Type of Report: Committee  
Council: 14 January 2019  
Expiry Date: 6 February 2019  
Application No: PLN-16-1133  
Address: 2 COLLINS STREET , HOBART  
ADJACENT ROAD RESERVE  
Applicant: (Fragrance TAS-HOBART (Collins) Pty Ltd)  
C/O PO Box 1271  
Proposal: Demolition and New Development for Visitor Accommodation, Function  
Centre and Associated Facilities  
Representations: 1459  
Performance criteria: Use; Conservation of Cultural Heritage Values; Urban Form; Public Urban  
Space; Demolition

- 1.1 Planning approval is sought for Demolition and New Development for Visitor Accommodation, Function Centre and Associated Facilities at 2 Collins Street and adjacent road reserve, Hobart.

*Image 2: Architect's render of the proposed development (Excerpt from proposal plans).*

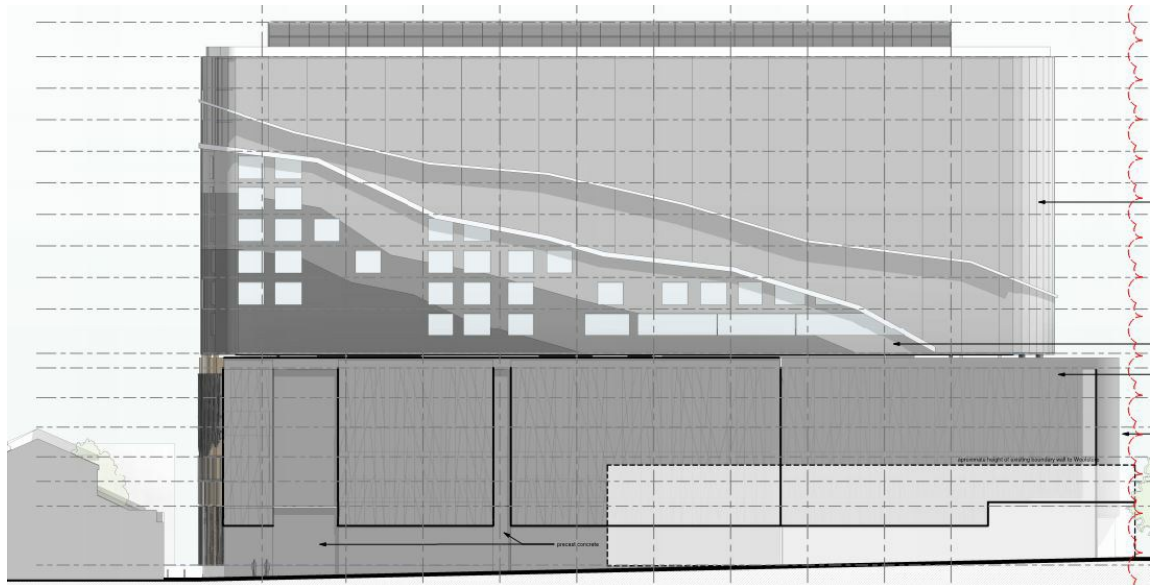
The mass and facade of the proposed building does not appropriately relate to the space that it forms. While at ground level the building provides glazing and some openings, and commercial activities encouraged by one of the objectives, above ground level the podium element of the building rises sharply above the street, albeit with some interest provided in the variable shape of the proposed awning on Collins Street.

The proposed building is clearly modern in its approach, however it is not evident that the design incorporates any relevant interpretation of the history of the area, nor does it appear to incorporate any historic cues. The use of sandstone facing throughout the podium level as a more traditional material is noted.

*By virtue of the height of the proposed hotel structure, the proposal will clearly dominate adjacent places of cultural significance when viewed from the street and other public spaces, and will be more prominent in the street than the adjacent places of cultural significance.*

*The area of the façade of the proposed new building will radically exceed that of the adjacent places of cultural significance. Any objective assessment would suggest that the visual impact of the apparent disparity of scale is significant. There is no historic precedent to warrant such scale disparity.*
